TPB Ref.: A/YL-KTN/1189

Proposed Temporary Warehouse (Excluding Dangerous Goods Godown) & Associated Filling of Land for a Period of 3 Years at Lots 953 S.B, 953 S.C, 956 (Part), 960RP (Part), 961 RP (Part), 1065 (Part), 1072, 1074, 1075, 1077 (Part), 1081 S.A RP, 1081 S.B RP, 1082 (Part), 1086 & 1088 in D.D. 107 & Adjoining Government Land, Kam Tin, Yuen Long, New Territories

KTN/1189 R-to-C

D01-1

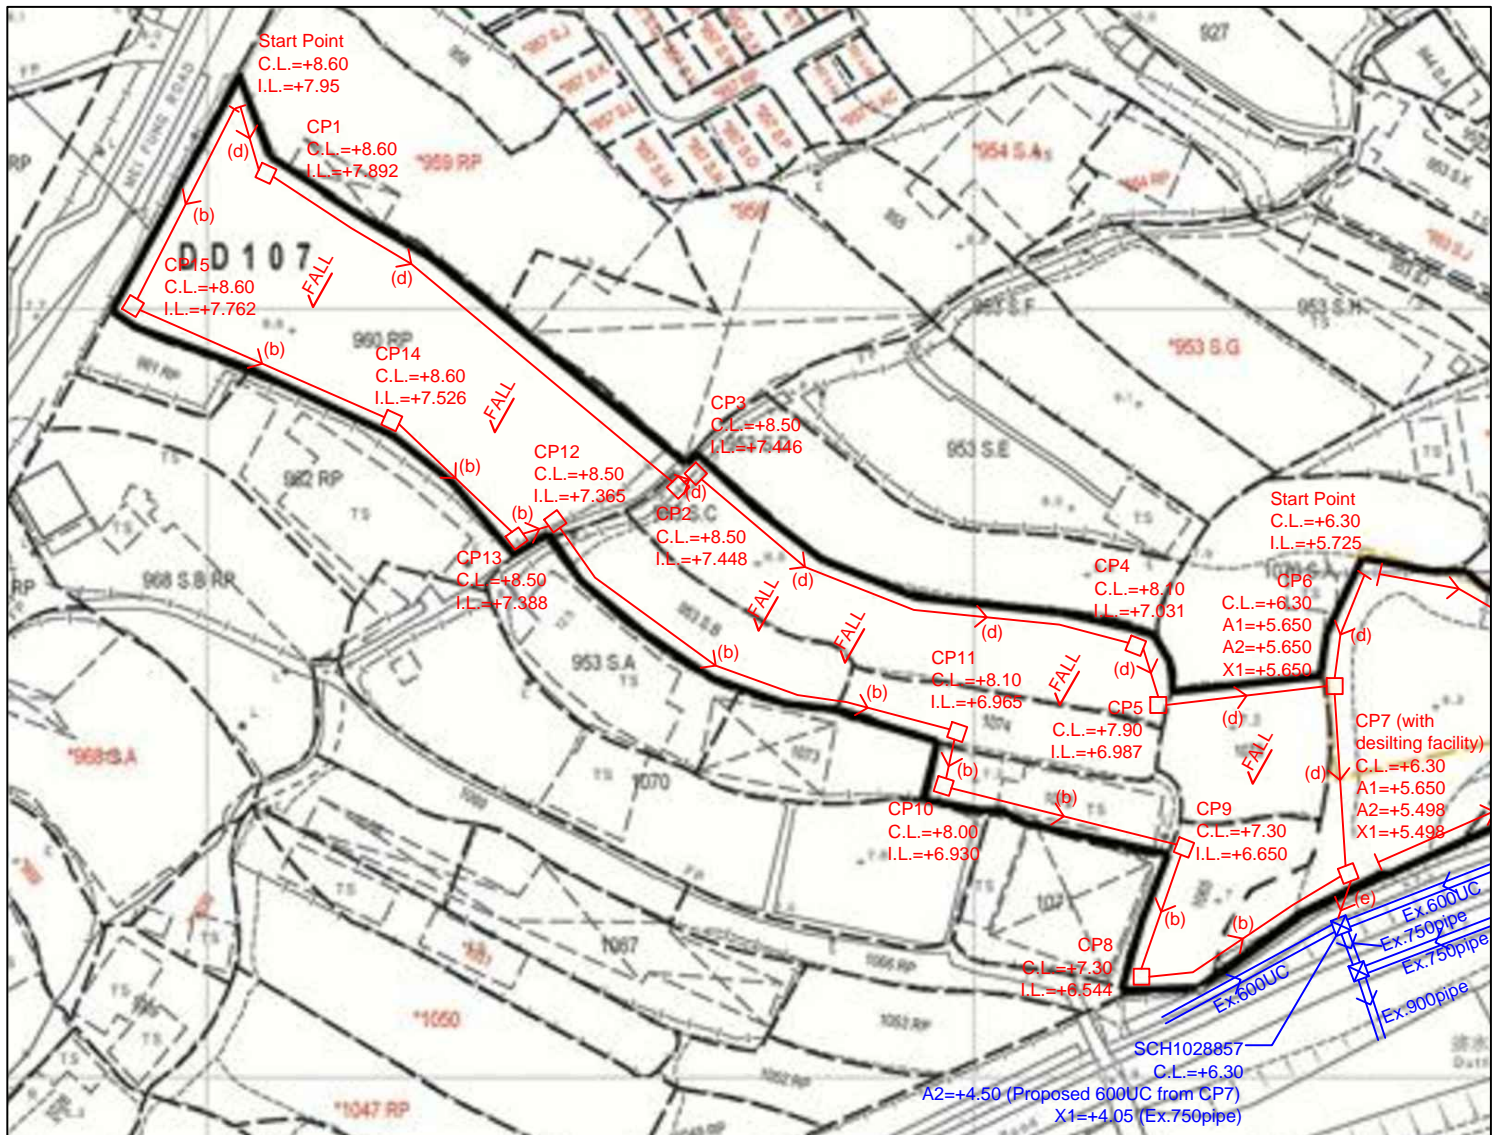
- (13) The invert level is revised accordingly.
- (14) Catchpit is provided in every turning point.
- (15) Catchpit schedule is provided.
- (16) The proposed size of u-channels is indicated in Drawing (D01-1) and (D02)

D01-2

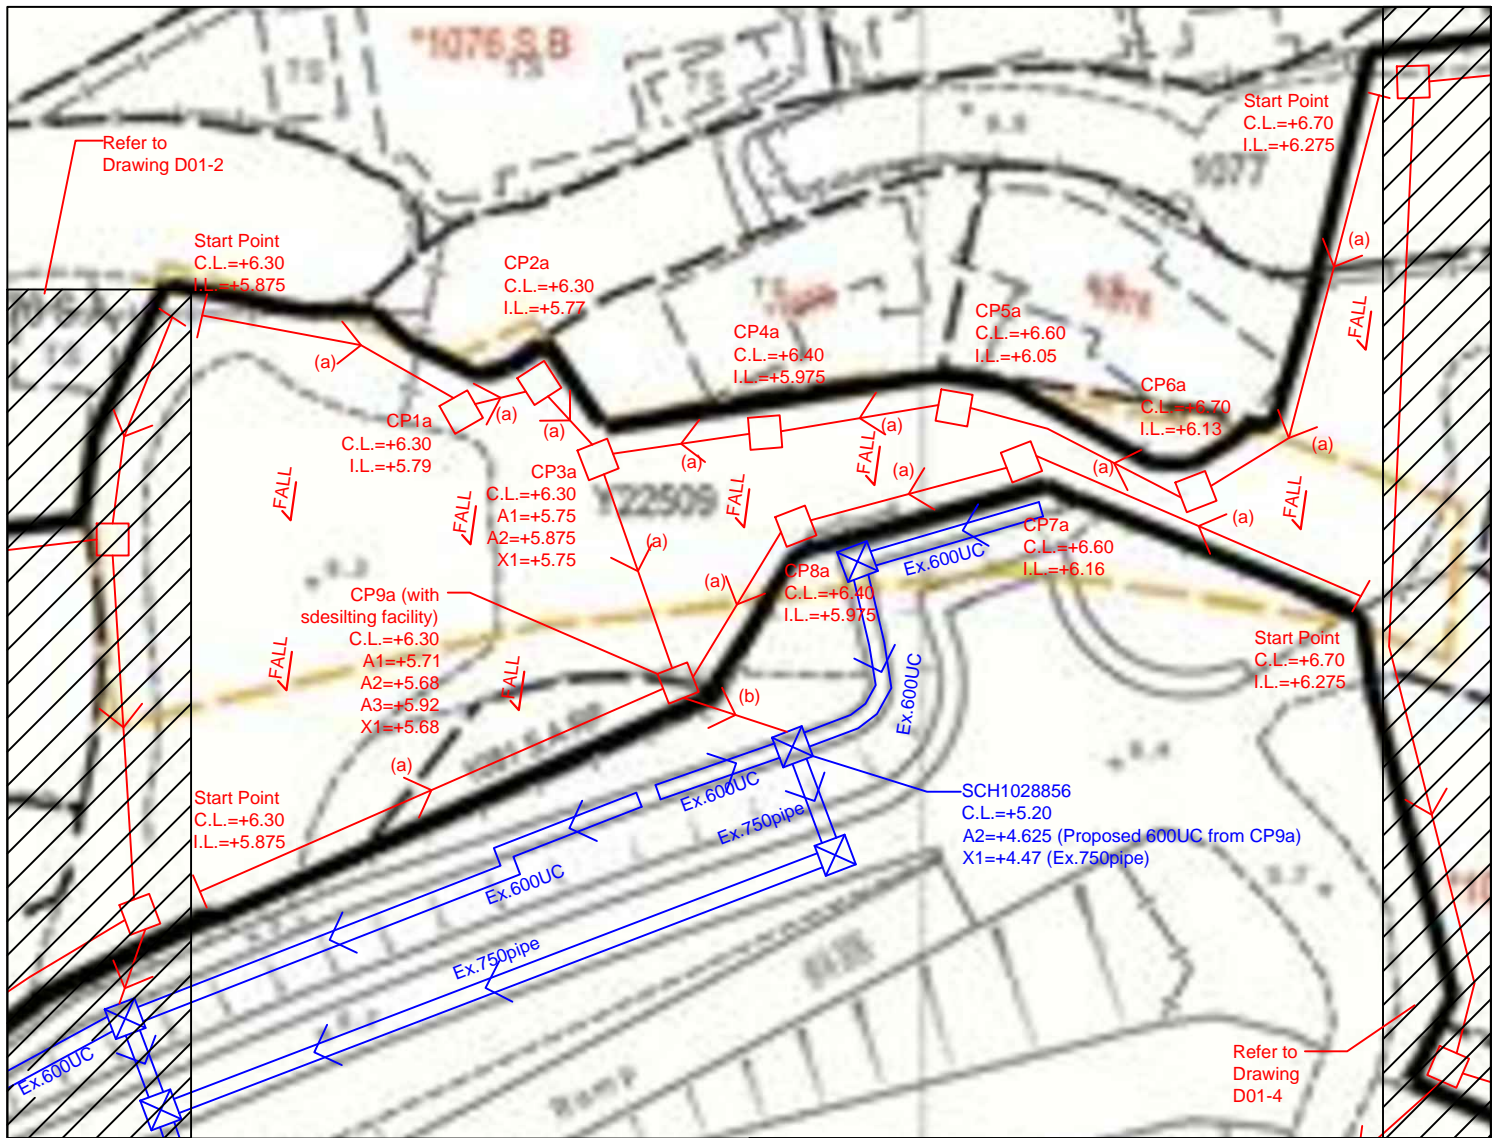
- (8) Deposition of sediment is considered in the design calculation (0.9 factor is applied).
- (9) The size and gradient of the proposed drainage facilities is indicated in Drawing (D01-2), and the typo is revised accordingly.

D01-4

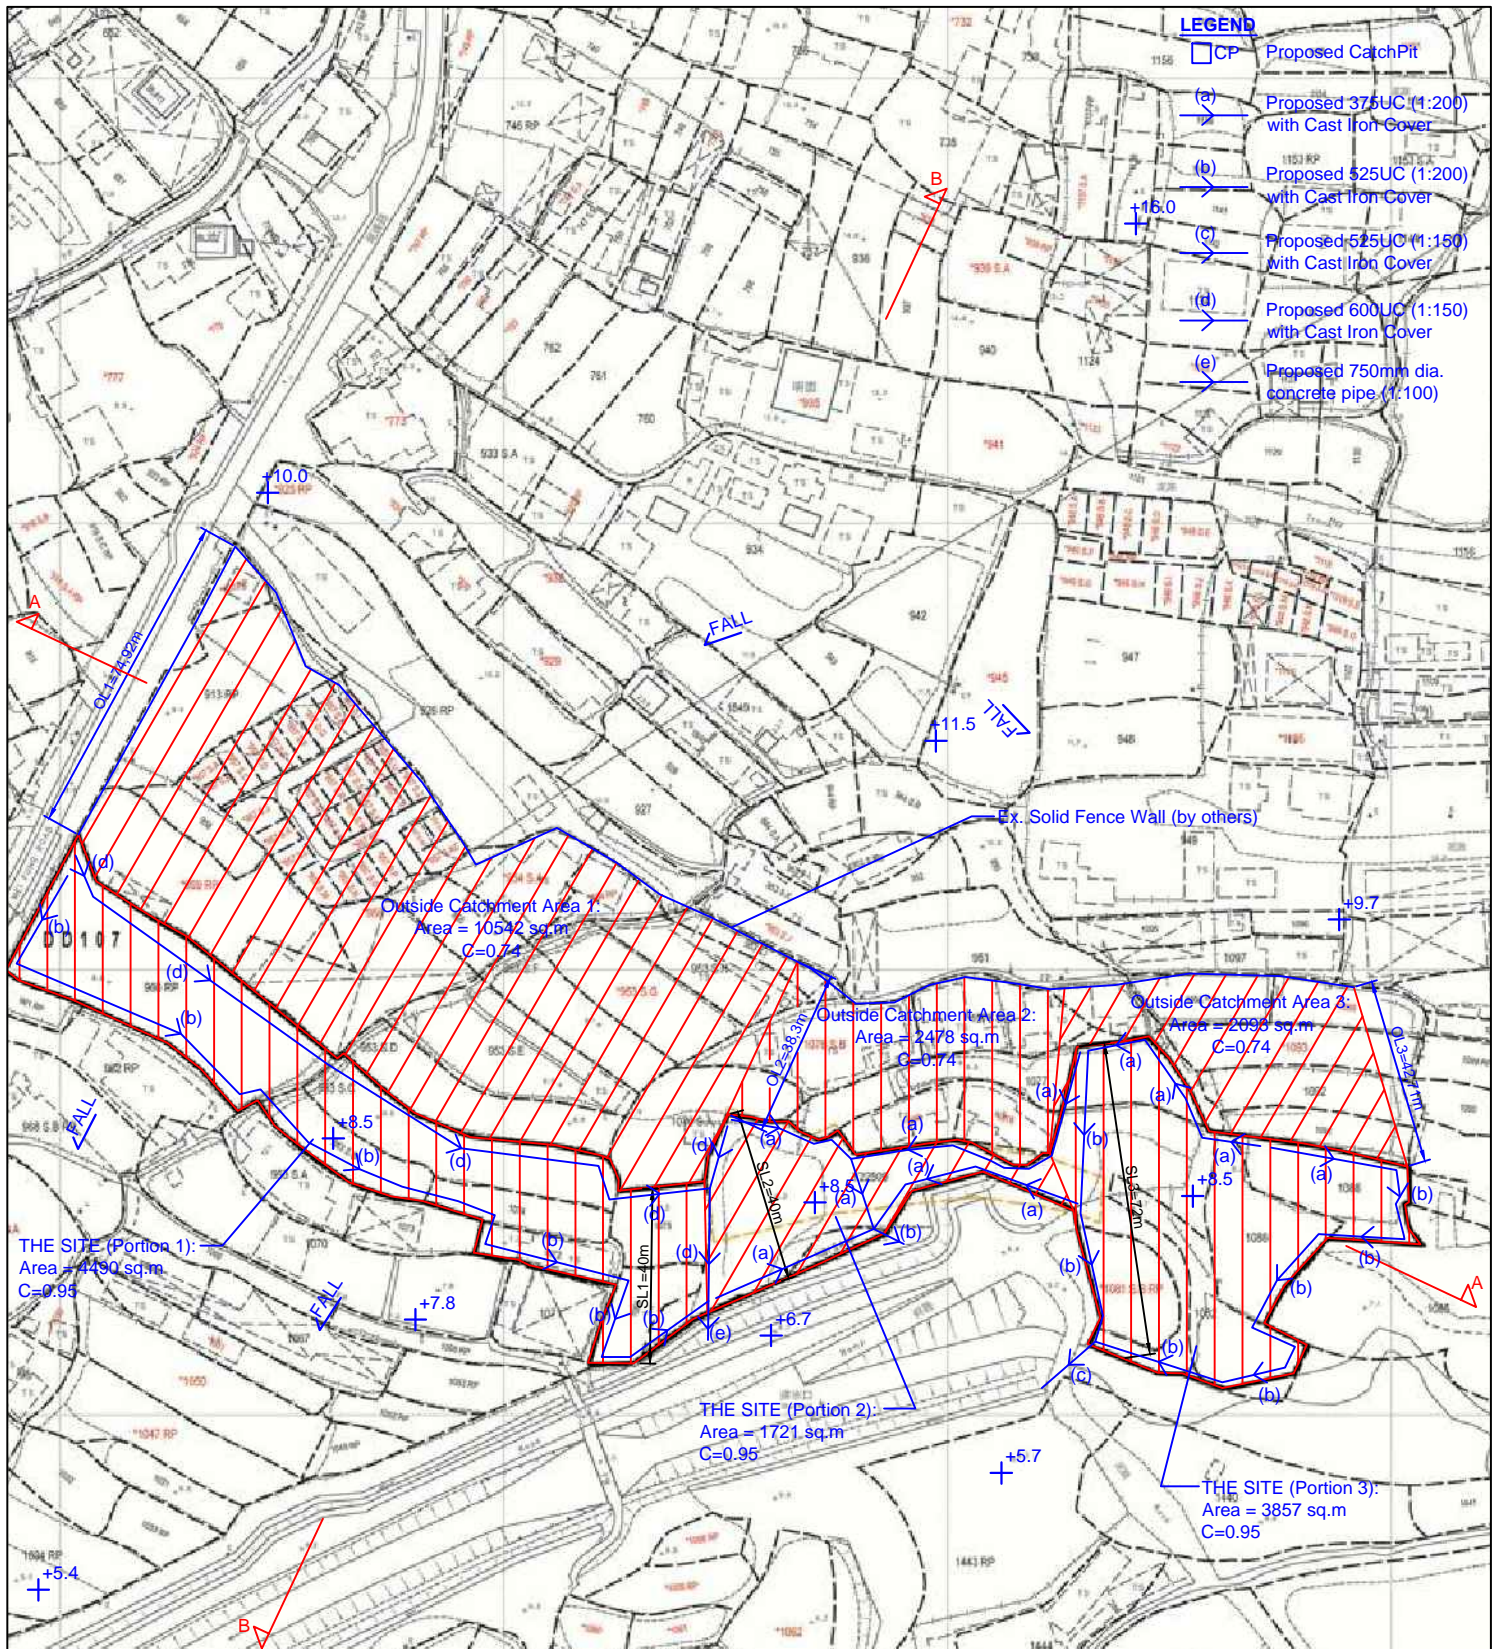
- (11) The ID nos and size of the existing public drainage facilities is indicated in Drawing (D01-4).
- (12) It should be CP4b, the note is revised accordingly.

D03

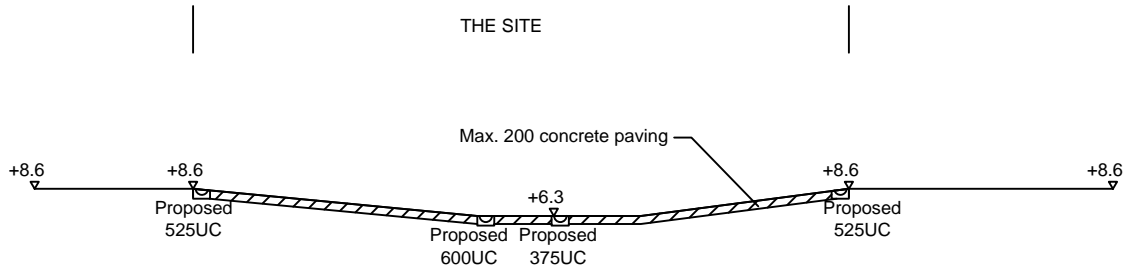
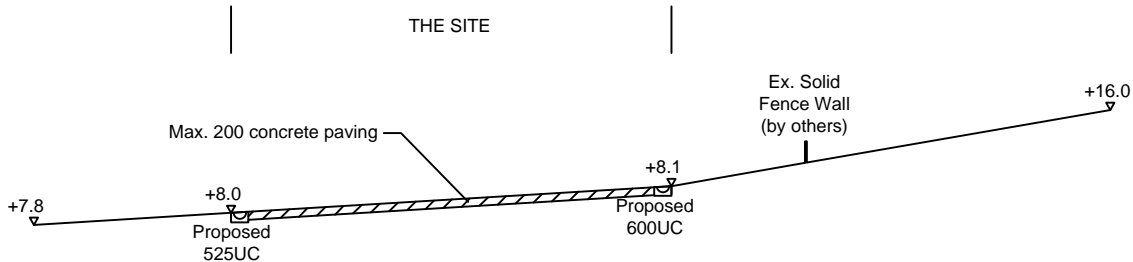
- (3) Cross sections are provided.
- (4) Hydraulic calculation is provided.
- (5) Outside catchment area is revised. Please note that there is existing solid fence wall in the north of the site.
